SUBSURFACE WASTEWATER DISPOSAL SYSTEM APPLICATION

PROPERTY ADDRESS	
Town Or Plantation	Augusta
Street	Leavitt Road
Subdivision Lot #	
PROPERTY OWNERS NAME	
Last:	Hanson, Jr.
First:	Henry R.
Applicant Name:	Henry R. Hanson, Jr.
Mailing Address of Owner/Applicant (If Different)	RFD 2, Box 1458 Augusta, Maine 04330

SUBSURFACE WASTEWATER DISPOSAL PLAN

Subject: Replacement System Variance to the Maine Subsurface Wastewater Disposal Rules, Hanson property, Leavitt Road, Augusta

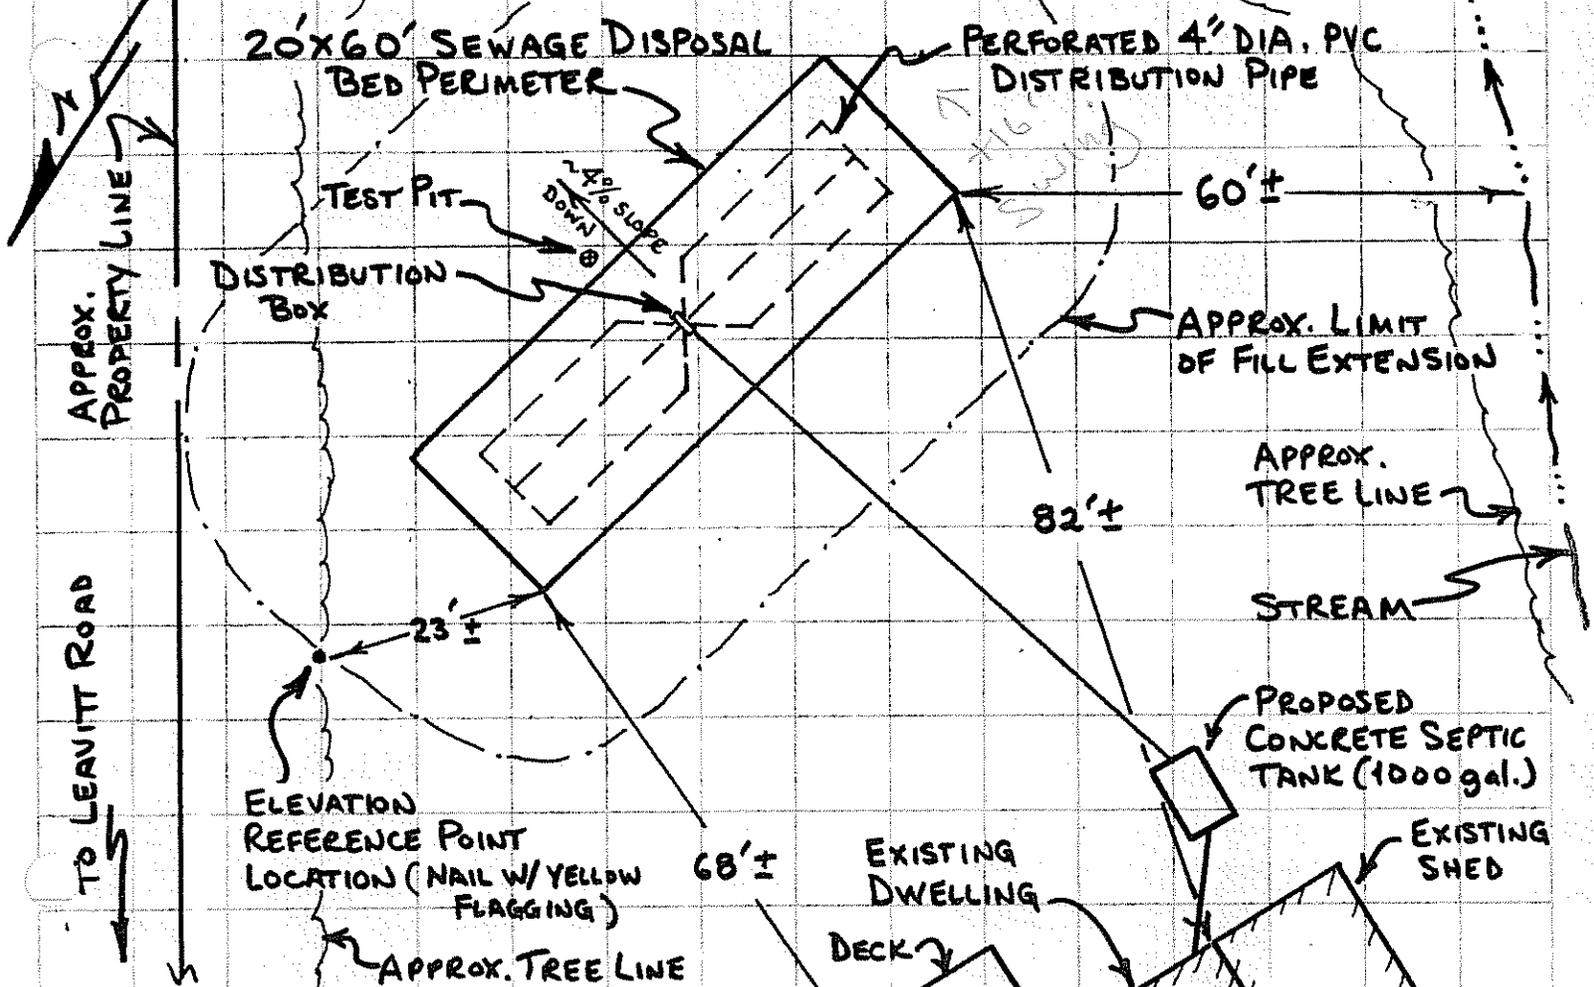
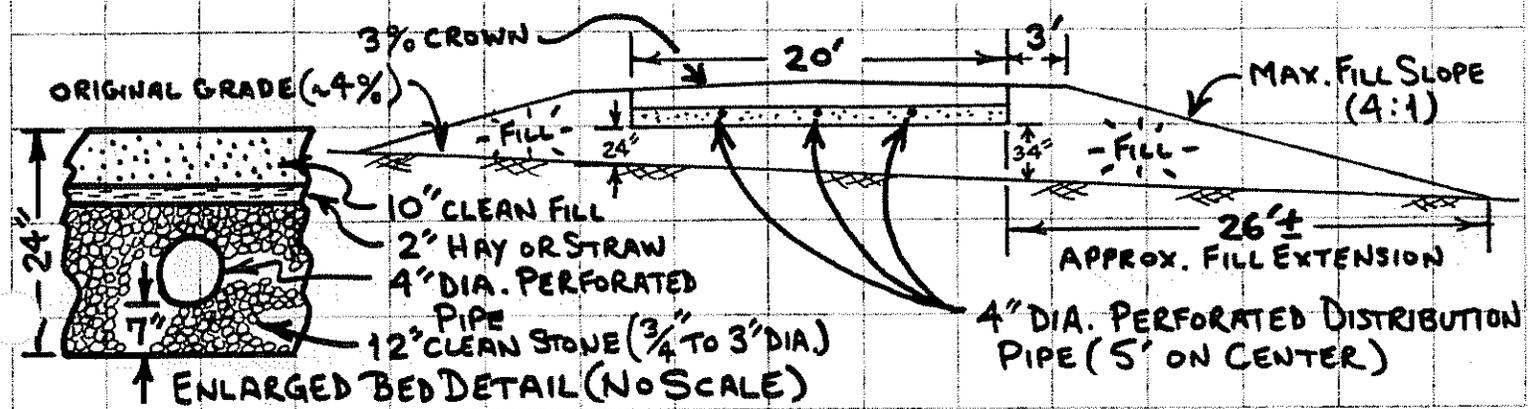
A completed HHE-200 Form by William T. Noble SE.; a completed HHE-204 Form signed by Henry R. Hanson, Jr., property owner; William T. Noble, SE., and Robert St. Pierre, LPI. The above is accepted as a complete application for variance to the Subsurface Wastewater Disposal Rules. A replacement subsurface disposal system cannot be installed on the subject property in full compliance with the Rules because of surface mottling on a 9E soil, the reasons for the variance request.

The installation of a 1000 gallon septic tank followed by a 1200 square foot disposal bed.

At least 48 inches and 58 inches of fill shall be applied on the uphill and downhill sides of the disposal field, respectively. The fill shall be of a texture similar to the original soil and will provide a 24 inch separation between the bottom of the disposal bed and the seasonal high water table and impervious layer. The fill must be extended in all directions as required by Section 11.D of the Subsurface Wastewater Disposal Rules.

In all other respects the installation is to comply with the Subsurface Wastewater Disposal Rules and follow the plan submitted with this proposal.
